Bailey of Bristol Caravan Technical Bulletin Alicanto Grande – CPL Retro-Fit

Document SOP: Z-SOP-RPC-P-SP-0005 - Alicanto CPL Retro-Fit

ALICANTO C.P.L RETRO-FIT

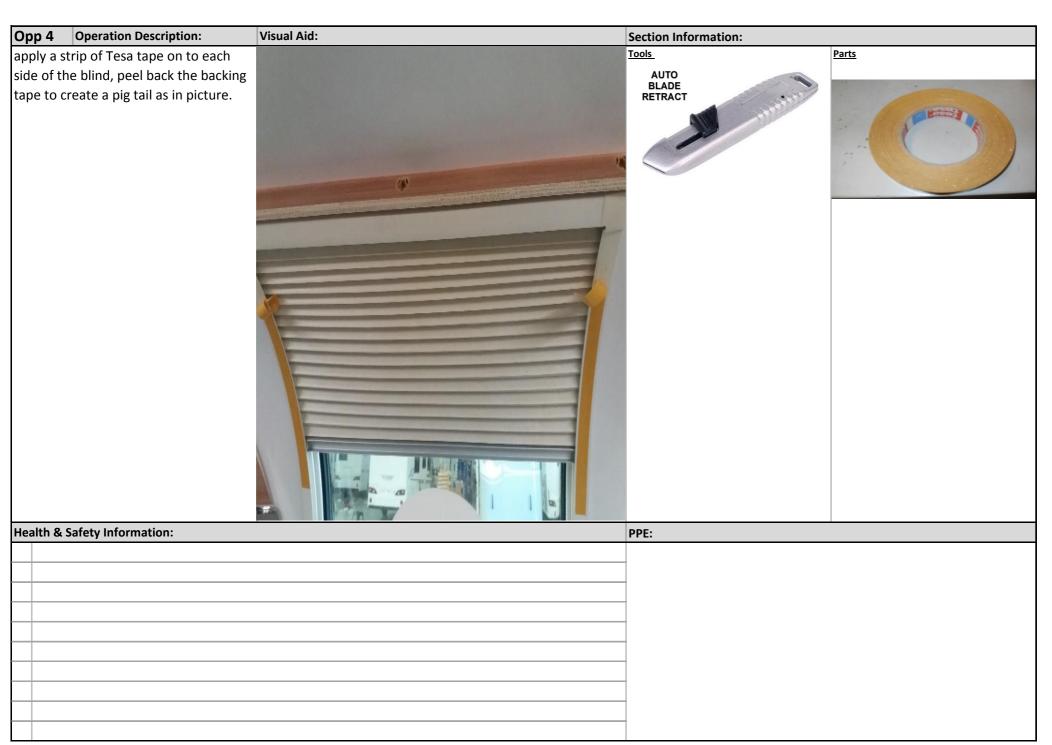
Эрр 3	Operation Description:	Visual Aid:	Section Information:	
careful	y remove Velcro from blind and	1.12 - 1.	<u>Tools</u>	<u>Parts</u>
upright	s, cut down uprights to a length	The state of the s		
of 1350	mm up from the bottom.			
		1.1		
		The state of the s		
Health 8	& Safety Information:		PPE:	
+
